CONDITIONS OF APPROVAL:

4338 & 4340 S Carothers Rd - Plans (4-26-18).pdf

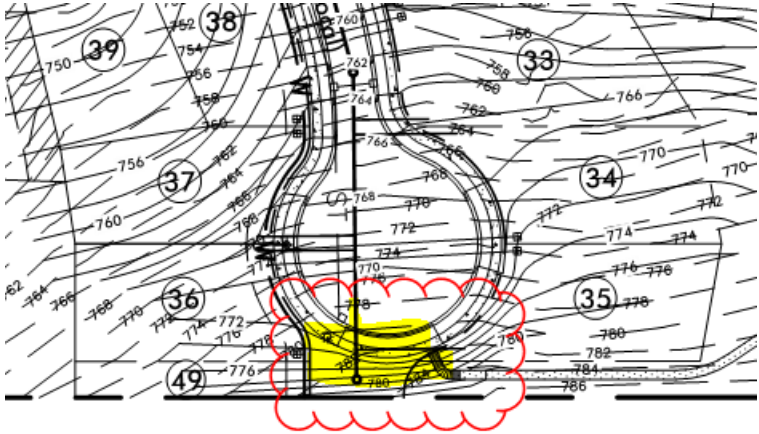
andyk@franklintn.gov Applicant shall plan on providing residential sprinkler system in each home until Milcrofton Utility District can provide information on water pressure.

Original Comment: "Since you cannot provide an estimate of water, we cannot recommend approval of this project. You may want to provide fire sprinkler in all homes if adequate water is not available."
